PIC16F630/676 Rev. A Silicon/Data Sheet Errata

The PIC16F630/676 parts you have received conform functionally to the Device Data Sheet (DS40039E), except for the anomalies described below.

Clarifications/Corrections to the Data Sheet:

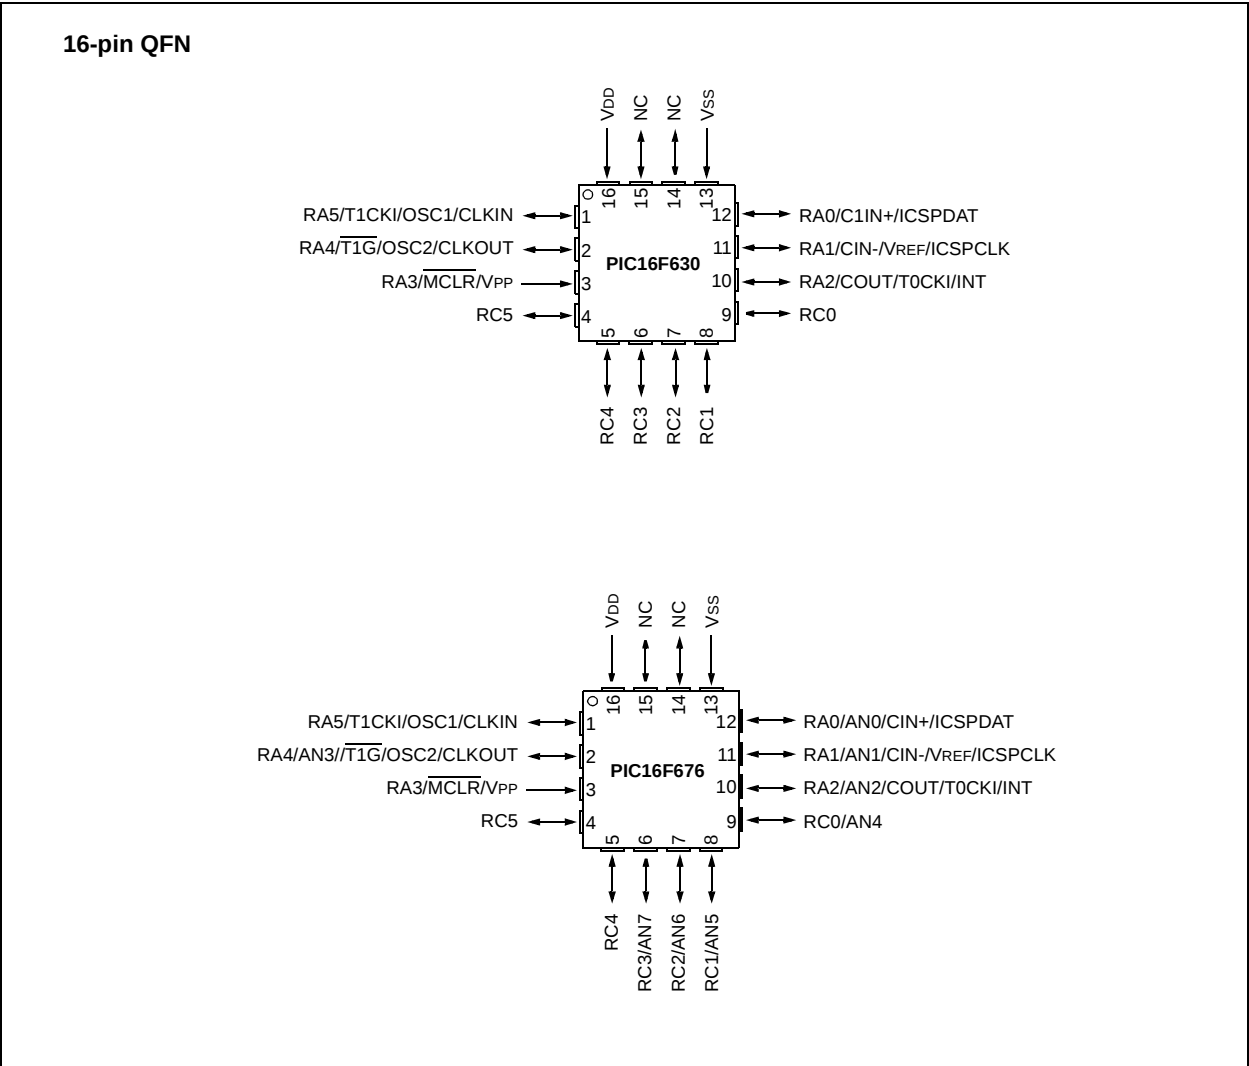
In Section 9.4.1, RA2/INT Interrupt, in the note box:

Note: The ANSEL (**91h**) and CMCON (19h).....

16-Lead Plastic Quad Flat, No Lead Package (ML) – 4x4x0.9 mm Body [QFN]

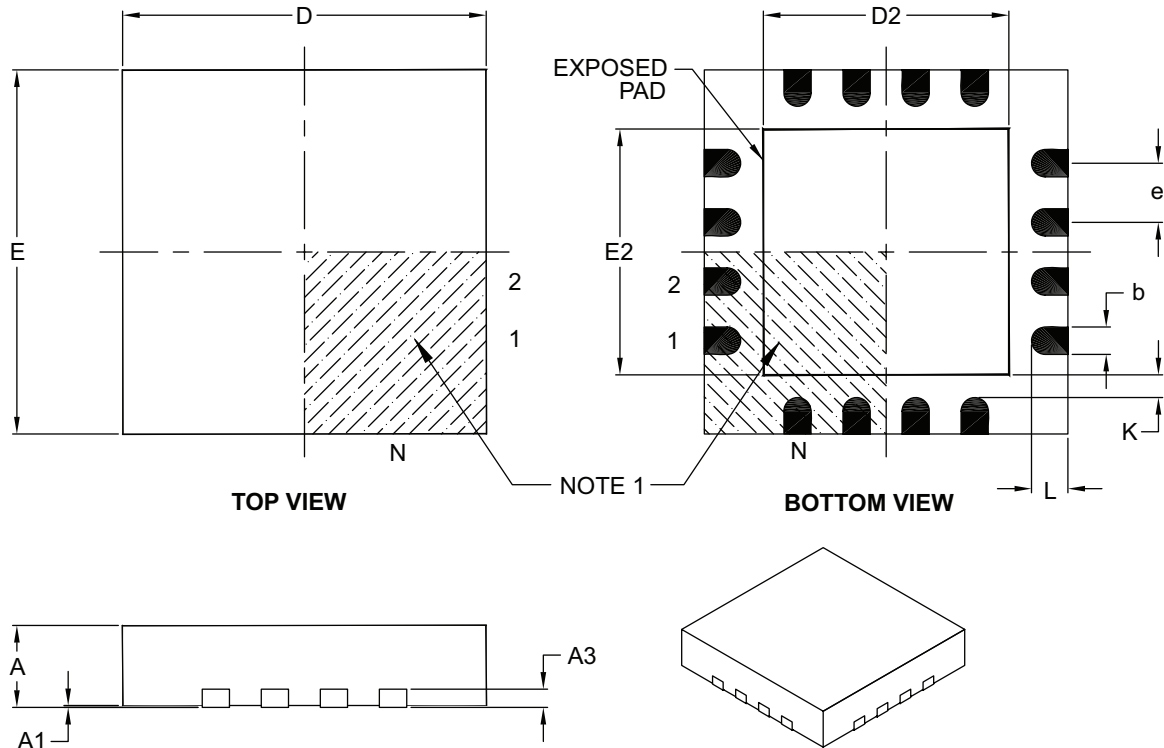
4. Module: New 4x4 QFN Package Added

The new 16-pin 4x4 QFN pinout diagrams will be added to the Pin Diagrams figure on page 2 and the Packaging Information chapter as shown below:
